Process Change Notification

Issue No. MPD-20-001
Issue Date : 16th Apr. 2020

PCN information : Regarding additional Assembly production site of Power Diode products

DO-214AC PMDS Package
Comparison between Rohm - OEM (PANJIT)

Dimension Specification / Recommended Foot Print

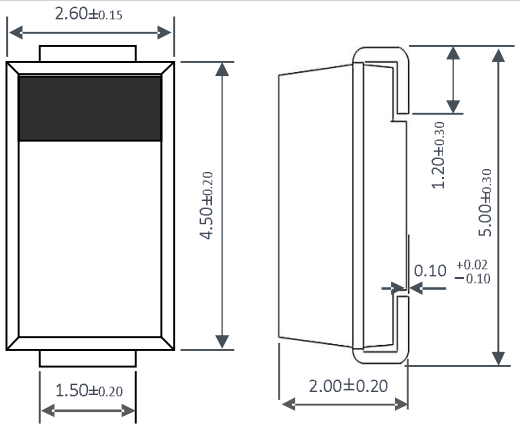
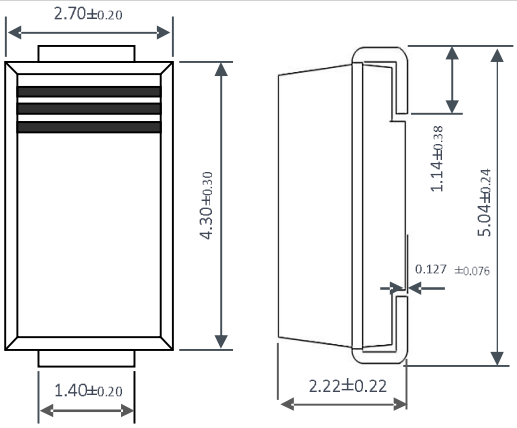
Item	ROHM Product	OEM (PANJIT)
	DO-214AC (PMDS/SMA)	DO-214AC (SMA)
Back End Facility	ROHM Semiconductor (China) Co.,Ltd. ROHM-Wako Electronics (Malaysia) Sdn. Bhd.	PAN JIT – China
Dimension	**Different *Please see detail in Page 2**	
Foot Print	No Differences	
Terminal Process	Dip Sn-3Ag-0.5Cu	Electroplating Sn 100%
Marking Process	Laser Marking – Mask Type	Laser Marking – Scan Type
Marking Symbol	**Different *Please see detail in Page 3**	
Inner Structure	Solder Interlocking Type (Marking Side : Anode)	Solder Interlocking Type (Marking Side : Cathode) ***Please see detail in Page 4**
Resin	Halogen Contained	Halogen Free
Internal Chip	No Changes	
Reel / Taping	**Different *Please see detail in Page 5-6**	
Packing Material	**Different *Please see detail in Page 7**	
Absolute Max	No Changes	
Electric Characteristics	No Changes

Inner Structure

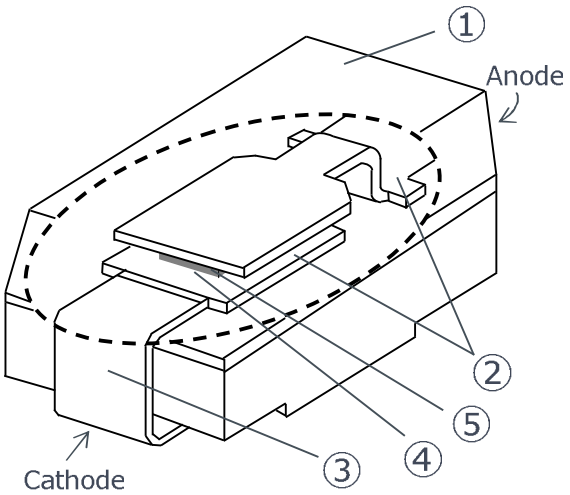
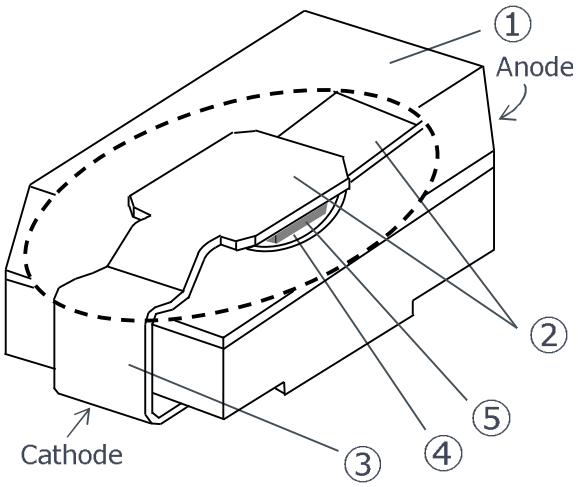
No.	Item	Material
①	Compounds	Epoxy (Halogen Contained)
②	Lead Frame	Cu / No first plating
③	External Plating	Solder Dip (Sn-3Ag-0.5Cu)
④	Die Attach	Die Bonding Material (Sn-Ag-Pb) (Not subject to RoHS)
⑤	Die	Silicon

No.	Item	Material
①	Compounds	Epoxy (Halogen Free)
②	Lead Frame	Cu / No first plating
③	External Plating	Electroplating (Sn 100%)
④	Die Attach	Die Bonding Material (Sn-Ag-Pb) (Not subject to RoHS)
⑤	Die	Silicon

Taping Specification

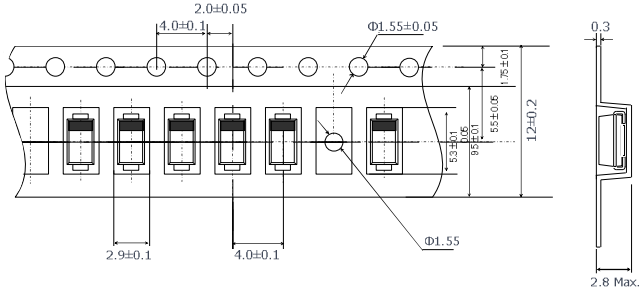
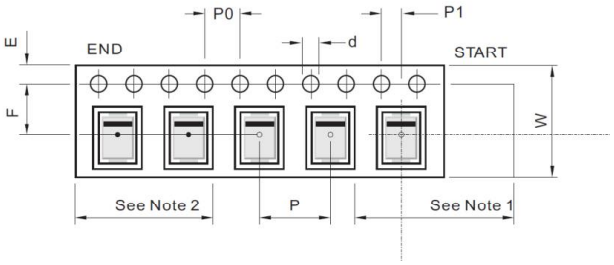
Note: 1.The beginning of taping contains adhesive taping (min. 600mm) and carrier taping with no parts (min. 110mm). 2.The end of taping contains carrier taping with no parts (min. 50mm)	■Taping Form

Note: 1.The beginning of taping contains adhesive taping (min. 230mm) and carrier taping with no parts (min. 160mm). 2.The end of taping contains carrier taping with no parts (min. 160mm)

Reel Specification

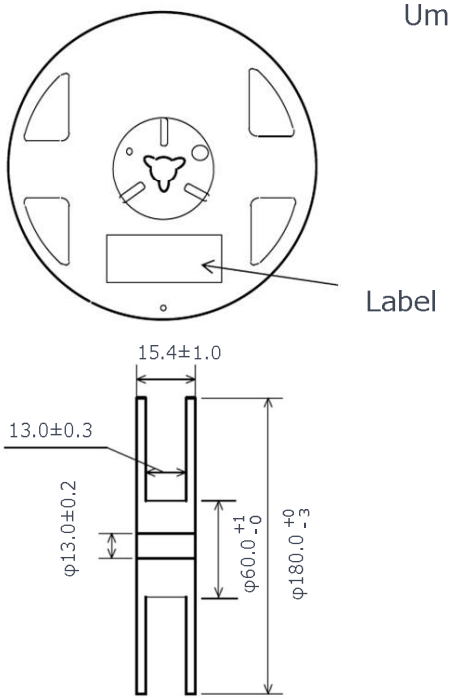
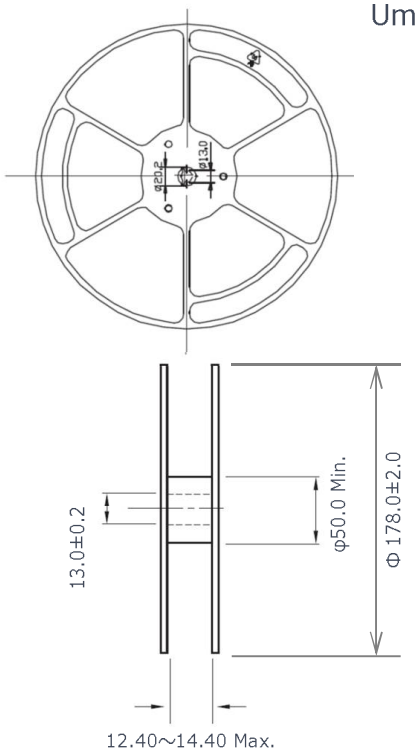
MOQ：1,500pcs/reel Color：White (Translucent)	Umit:mm

MOQ：1,800pcs/reel Color：Blue

Packing Specification

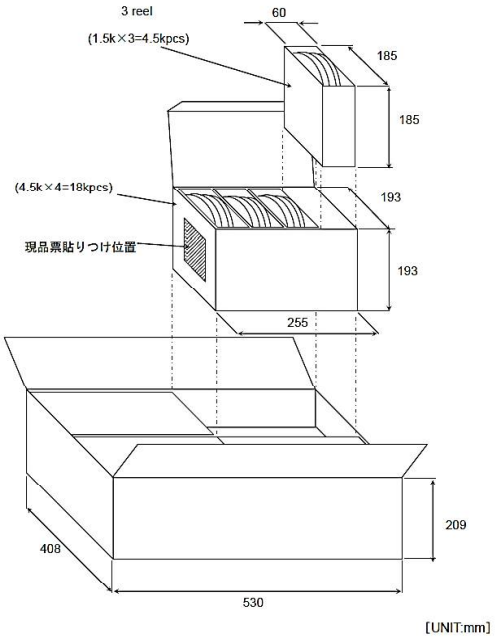
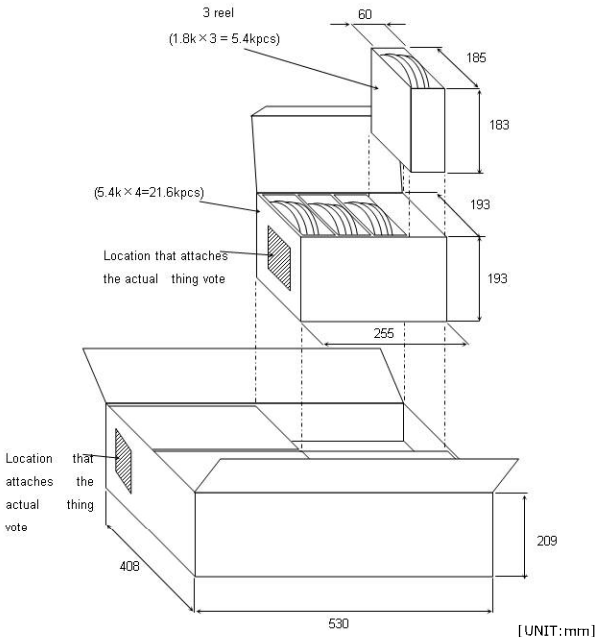
基準数量に満たない場合は、スペーサーを使用してリールがダンボール箱内を動くことを防ぐ。 **Item** / **Content** Inner Box: L x W x H (mm)：193 x 255 x 193 ＜1500pcs/reel x 12reels : Max.18.0kpcs ＞ Outer Box: L x W x H (mm)：408 x 530 x 209 ＜ 中箱 x 4box : Max.72.0kpcs ＞

基準数量に満たない場合は、スペーサーを使用してリールがダンボール箱内を動くことを防ぐ。 **Item** / **Content** Inner Box: L x W x H (mm)：193 x 255 x 193 ＜1800pcs/reel x 12reels : Max.21.6kpcs ＞ Outer Box: L x W x H (mm)：408 x 530 x 209 ＜ 中箱 x 4box : Max.86.4kpcs ＞

Dimension Specification / Recommended Foot Print

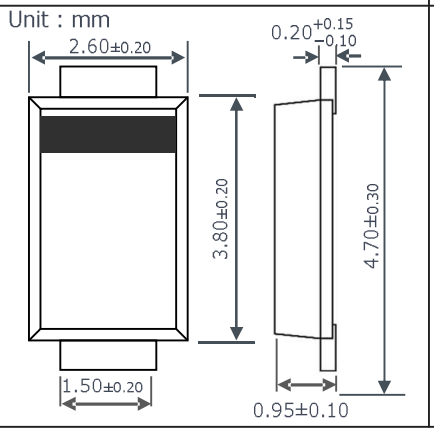
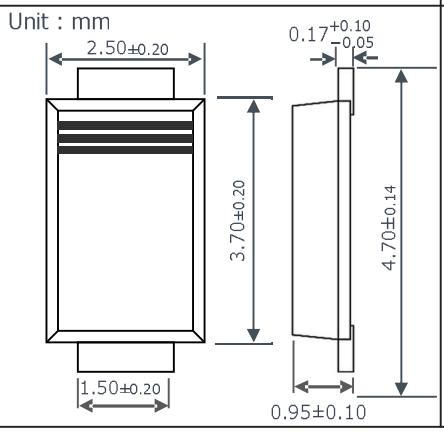
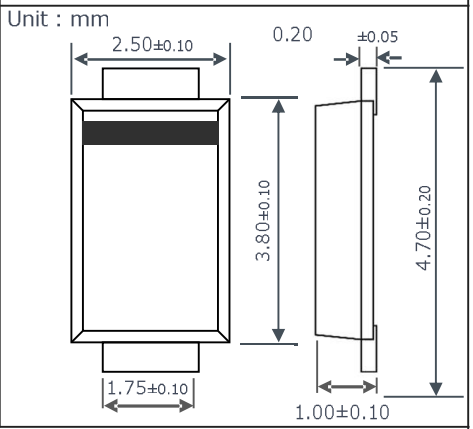
Item	ROHM Product		OEM(PAN JIT)
	SOD-128 (PMDT/SMAF)	SOD-128 (PMDTM/SMAF)	SOD-128
Backend Facility	ROHM-Wako Electronics (Malaysia) Sdn. Bhd.	ROHM Wako(Japan) ROHM-Wako Electronics (Malaysia) Sdn. Bhd.	PAN JIT – Taiwan
Dimension	**Different *Please see detail in Page 2**		
Foot print	No Differences		
Terminal Process	Solder Dip(Sn-3Ag-0.5Cu)	No Differences (Electroplating：Sn 100%)	
Marking Process	Laser Mask	No Differences (Laser Marking-Scan Type)	
Marking Symbol	**Different *Please see detail in Page 3**		
Structure	No Differences (Solder Interlocking Type)		
Resin	Halogen	No Differences (Halogen Free)	
Element(Wafer)	No Differences		
Reel	**Different *Please see detail in Page 4/5**		
Packing Material	**Different *Please see detail in Page 6**		
Absolute Max.	No Differences		
Electric Characteristics	No Differences

Taping Specification

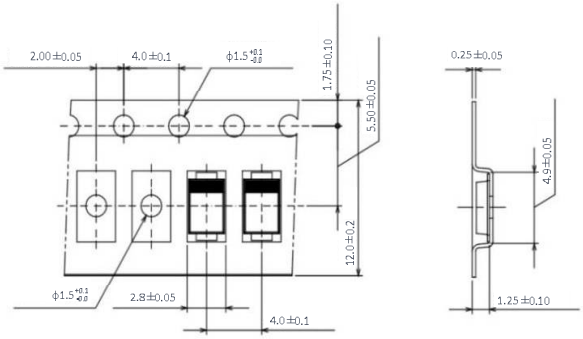
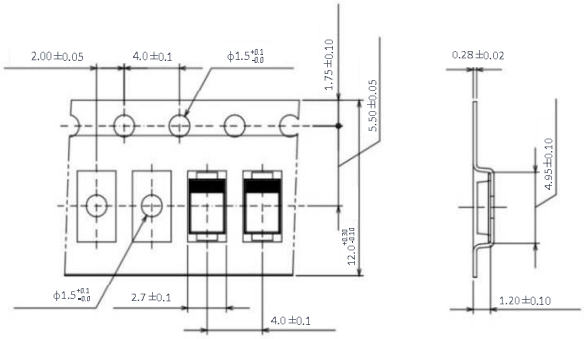
Item	ROHM Product	OEM(PAN JIT)
	SOD-128 (PMDT/PMDTM/SMAF)	SOD-128
Taping	■Taping Unit : mm

■Taping Unit : mm

Reel Specification

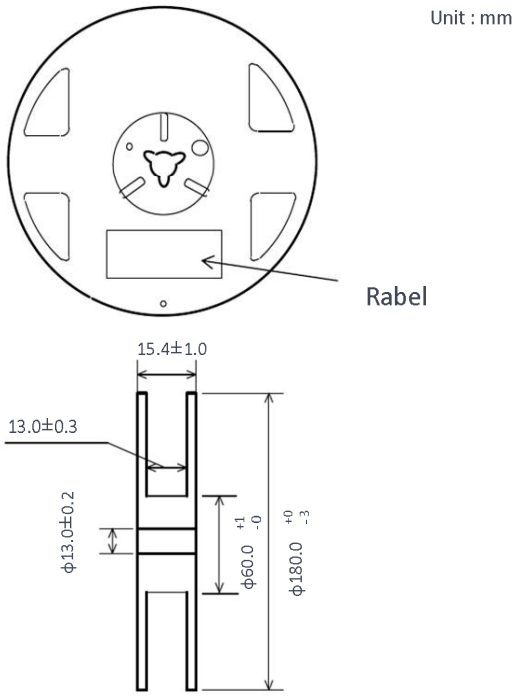
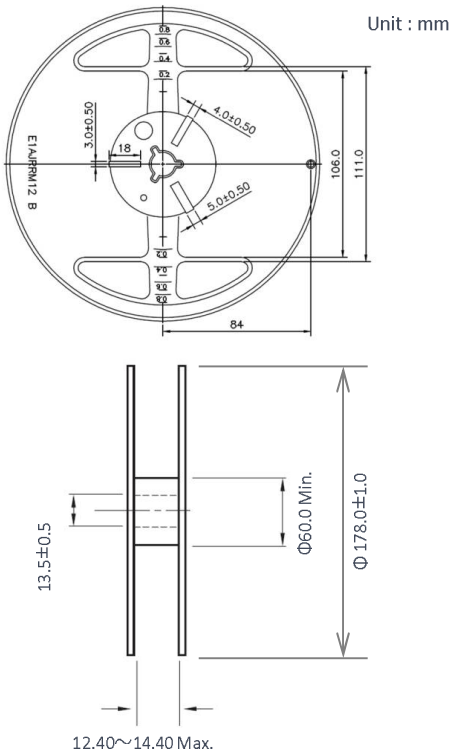
Qty：3,000pcs/Reel Color：White(Translucent)

Qty：3,000pcs/Reel Color：Blue

Packing Specification

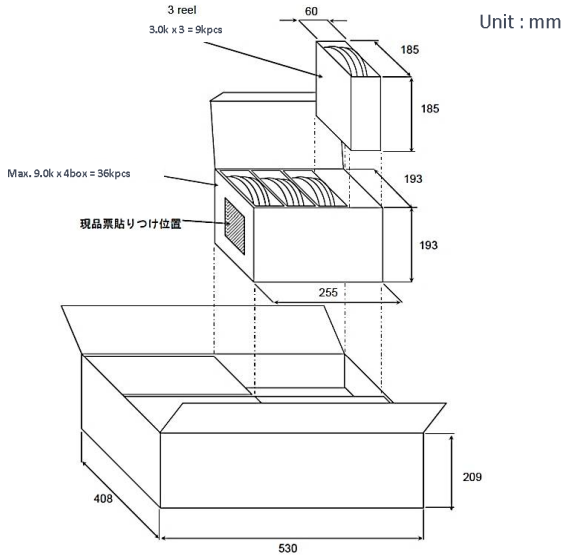
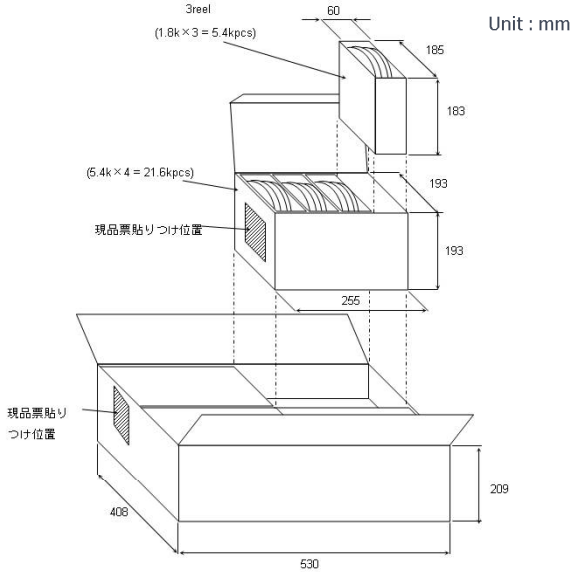
If lacking the standard qty, spacers are used to prevent the feels from moving in the cardboard box. <table><tr><th>Item</th><th>Content</th></tr><tr><td>Inside Box</td><td>L x W x H (mm)：193 x 255 x 193 ＜3kpcs/reel x 16reels : Max.48kpcs ＞</td></tr><tr><td>Outside Box</td><td>L x W x H (mm)：408 x 530 x 209 ＜ Inside Box x 4box : Max.192kpcs ＞</td></tr></table>

If lacking the standard qty, spacers are used to prevent the feels from moving in the cardboard box. <table><tr><th>Item</th><th>Contents</th></tr><tr><td>Inside Box</td><td>L x W x H (mm)：193 x 255 x 193 ＜3kpcs/reel x 12reels : Max.36kpcs ＞</td></tr><tr><td>Outside Box</td><td>L x W x H (mm)：408 x 530 x 209 ＜ Inside Box x 4box : Max.144kpcs ＞</td></tr></table>

Dimension Specification / Recommended Foot Print

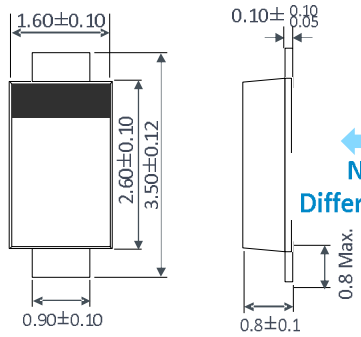
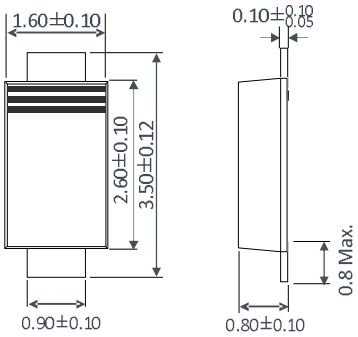
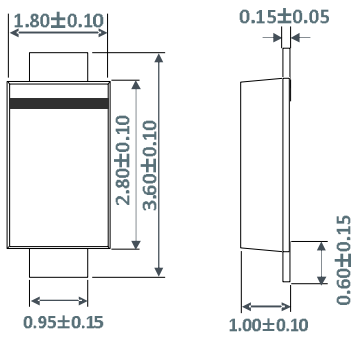
Item	ROHM Product		OEM(PAN JIT)
	SOD-123FL (PMDU) 【HOOP】	SOD-123FL (PMDU) 【WIDE】	SOD-123FL
Back End Facility	ROHM Semiconductor (China) Co.,Ltd. ROHM-Wako Electronics (Malaysia) Sdn. Bhd.	ROHM Wako(Japan) ROHM-Wako Electronics (Malaysia) Sdn. Bhd.	PAN JIT – Taiwan
Dimension	**Different *Please see detail in Page 2**		
Foot Print	No Differences		
Terminal Process	Dip Sn-3Ag-0.5Cu	Electroplating Sn 100%	Electroplating Sn 100%
Marking Process	Laser Marking – Mask Type	Laser Marking – Scan Type	Laser Marking – Mask Type
Marking Symbol	**Different *Please see detail in Page 3**		
Structure	No Changes ＜Solder Interlocking Type (Marking Side : Anode)＞		
Resin	Halogen Contained	Halogen Free	
Element (Wafer)	No Changes		
Reel	**Different *Please see detail in Page 4/5**		
Packing Material	No Changes		
Absolute Max	NO Changes		
Electric Characteristics	No Changes

Marking Specification / Internal Construction

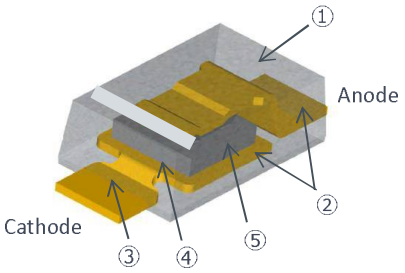
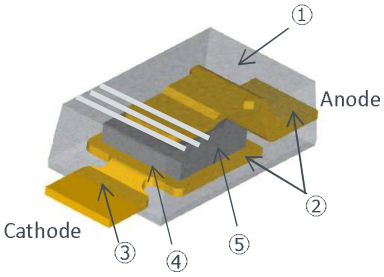
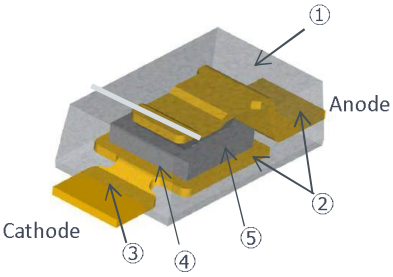
No.	Item	Material
①	Resin	Epoxy Resin(Halogen)
②	Lead Frame	Copper/ No base plating
③	Terminal Process	Solder Dip (Sn-3Ag-0.5Cu)
④	Chip Junction	Die Bonding (Sn-Ag-Pb)
⑤	Chip	Silicon

No.	Item	Material
①	Resin	Epoxy Resin(Halogen Free)
②	Lead Frame	Copper/ No base plating
③	Terminal Process	Electroplating(Sn)
④	Chip Junction	Die Bonding(Sn-Ag-Pb)
⑤	Chip	Silicon

No.	Item	Material
①	Resin	Epoxy Resin(Halogen Free)
②	Lead Frame	Copper / No base plating
③	Terminal Process	Electroplating(Sn)
④	Chip Junction	Die Bonding (Sn-Ag-Pb)
⑤	Chip	Silicon

Taping Specification

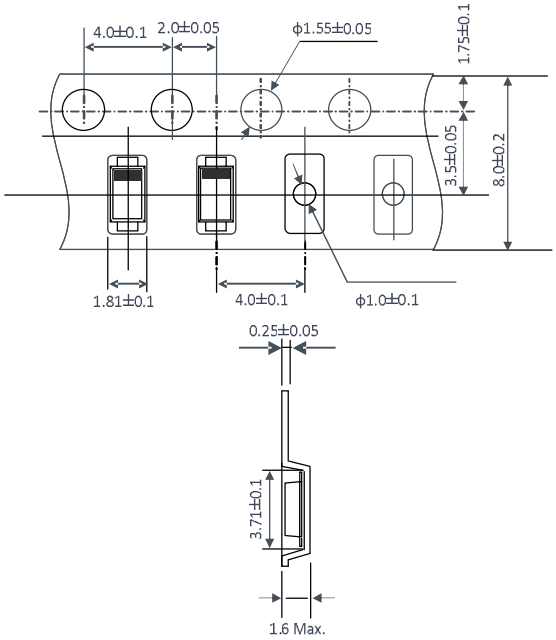
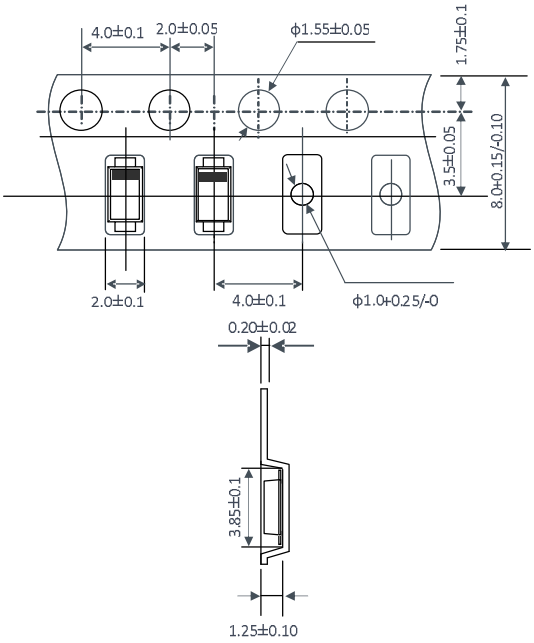
Note: 1. Adhesive tape only (Min. 600mm) and Carrier tape not containing products (Min. 110mm) area is in the beginning of the reel. 2.Product not contained carrier tape (min. 50mm) exists in the end of the reel.		■Taping

Note: 1. Adhesive tape only (Min. 230mm) and Carrier tape not containing products (Min. 160mm) area is in the beginning of the reel. 2.Product not contained carrier tape (min. 160mm) exists in the end of the reel.

Reel Specification

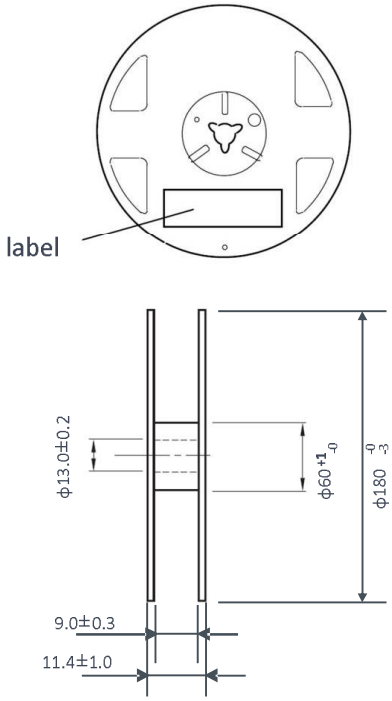
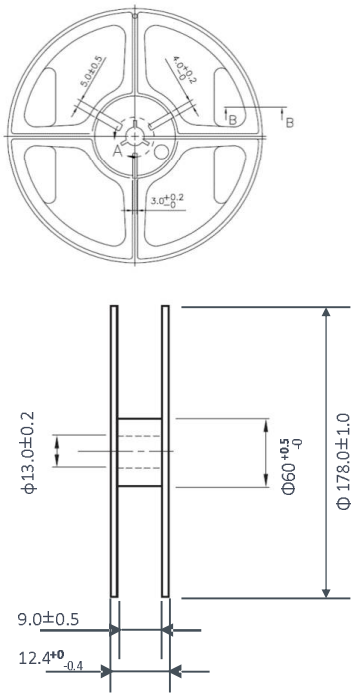
Qty：3,000pcs/Reel Color：White(Translucent)

Qty：3,000pcs/Reel Color：Blue
